PLANNING COMMISSION AGENDA

August 24, 2020

A. Preliminary Plat – Hillcrest Subdivision

Applicant: Nick Limbird Date: 8/4/2020 Project Name: Hillcrest Subdivision Engineer/Architect: Blew & Associates, PA Following are recommendations from the Technical Plat Review Committee that must be addressed prior to your application being submitted to the Planning Commission at its next regular meeting. The information must be submitted to the Planning Office before 12 noon the following Tuesday from the date above in order for the item to be placed on the agenda for the Commission meeting. A narrative addressing each comment must be submitted along with the revised plat. Representing: Farmington Fire Name: William Holland Remove island from culde-sac on Hillers Received By:

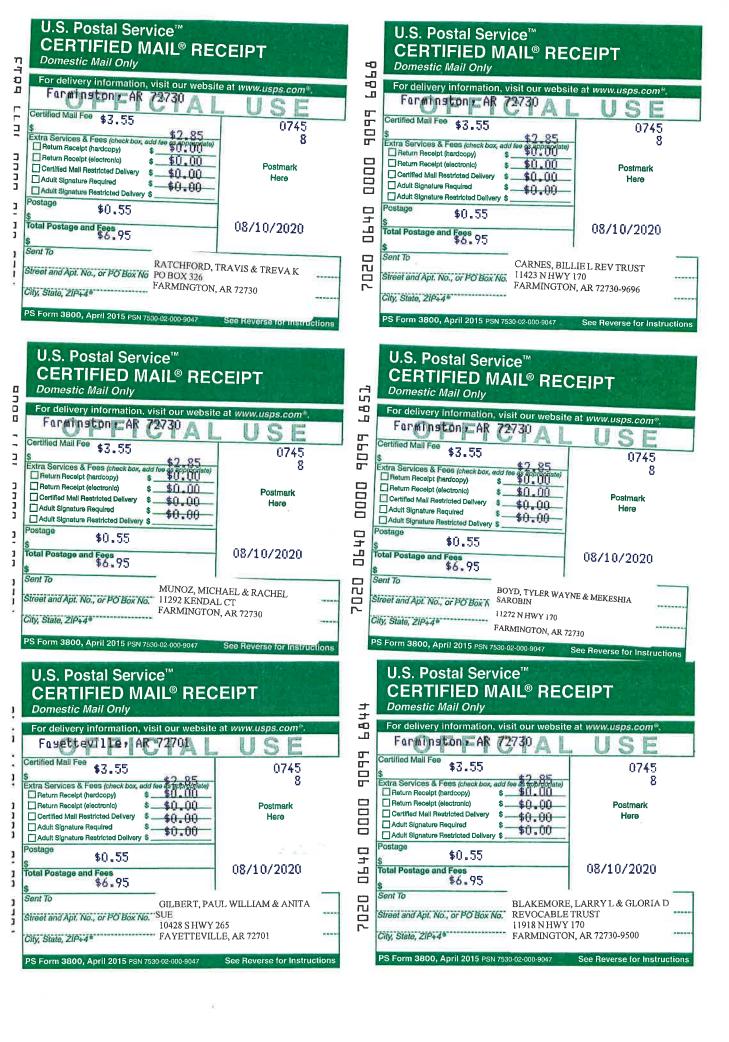
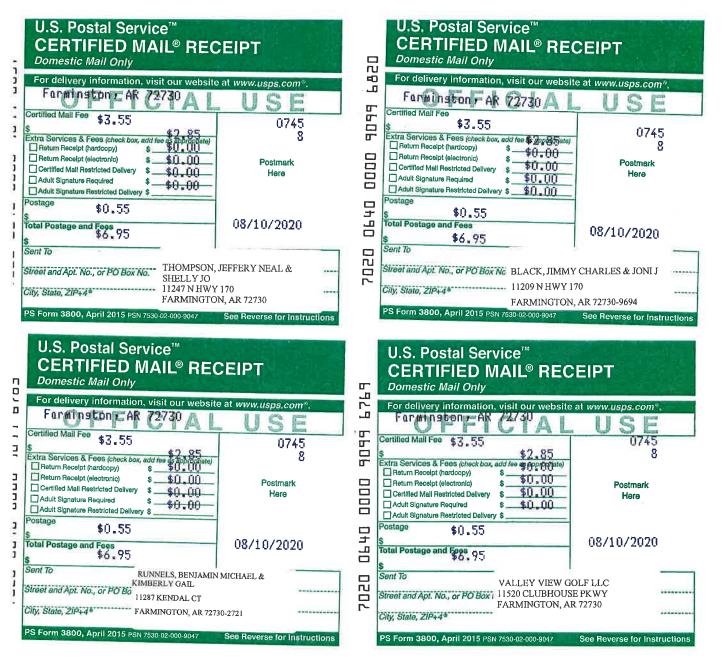
A PART OF THE SW1/4 OF THE NE1/4 OF SECTION 3, TOWNSHIP 15 NORTH, RANGE 31 WEST, WASHINGTON COUNTY, ARKANSAS, BEING MORE PARTICULARLY DESCRIBED AS FOLLOWS, TO-WIT: BEGINNING AT A SET IRON PIN FOR THE NORTHEAST CORNER OF SAID SW1/4 OF THE NE1/4, AND RUNNING THENCE ALONG THE EAST LINE OF SAID SW1/4 OF THE NE1/4 S02°30'18"W 429.13' TO A SET IRON PIN ON THE NORTHERLY RIGHT-OF-WAY OF ARKANSAS STATE HIGHWAY 170, THENCE LEAVING SAID EAST LINE AND ALONG SAID RIGHT-OF-WAY WITH A CURVE TO THE RIGHT, HAVING A RADIUS OF 893.70', AN ARC LENGTH OF 69.82', AND A CHORD BEARING AND DISTANCE OF S59°54'17"W 69.81', THENCE CONTINUING WITH SAID RIGHT-OF-WAY S62°08'34"W 162.16', THENCE S62°38'52"W 161.87' TO A SET IRON PIN, THENCE LEAVING SAID RIGHT-OF-WAY N05°28'12"E 630.77' TO A SET IRON PIN ON THE NORTH LINE OF SAID SW1/4 OF THE NE1/4, THENCE ALONG SAID NORTH LINE S87°22'39"E 306.49' TO THE POINT OF BEGINNING. CONTAINING 3.90 ACRES MORE OR LESS. SUBJECT TO EASEMENTS AND RIGHTS-OF-WAY OF RECORD.

ALSO LESS AND EXCEPT

A PART OF THE SW1/4 OF THE NE1/4 OF SECTION 3, TOWNSHIP 15 NORTH, RANGE 31 WEST, WASHINGTON COUNTY, ARKANSAS, BEING MORE PARTICULARLY DESCRIBED AS FOLLOWS, TO-WIT: A PART OF THE SW1/4 OF THE NE1/4 OF SECTION 3, TOWNSHIP 15 NORTH, RANGE 31 WEST, WASHINGTON COUNTY, ARKANSAS, BEING MORE PARTICULARLY DESCRIBED AS FOLLOWS, TO-WIT: BEGINNING AT A POINT WHICH IS S02°30'18"W 524.73' FROM THE NORTHEAST CORNER OF SAID SW1/4 OF THE NE1/4, SAID POINT BEING A SET IRON PIN ON THE SOUTHERLY RIGHT-OF-WAY OF ARKANSAS STATE HIGHWAY 170, AND RUNNING THENCE ALONG SAID EAST LINE S02°30'18"W 322.25' TO A SET IRON PIN, THENCE LEAVING SAID EAST LINE N86°40'03"W 219.53' TO A SET IRON PIN, THENCE N06°07'51"E 198.54' TO A SET IRON PIN ON THE SOUTHERLY RIGHT-OF-WAY OF ARKANSAS STATE HIGHWAY 170, THENCE ALONG SAID RIGHT-OF-WAY N62°38'52"E 55.76', THENCE N62°08'34"E 162.51', THENCE CONTINUING WITH SAID RIGHT-OF-WAY ALONG A CURVE TO THE LEFT, HAVING A RADIUS OF 973.70', AN ARC LENGTH OF 21.43', AND A CHORD BEARING AND DISTANCE OF N61°30'45"E 21.43' TO THE POINT OF BEGINNING. CONTAINING 1.26 ACRES MORE OR LESS. SUBJECT TO EASEMENTS AND RIGHTS-OF-WAY OF RECORD.
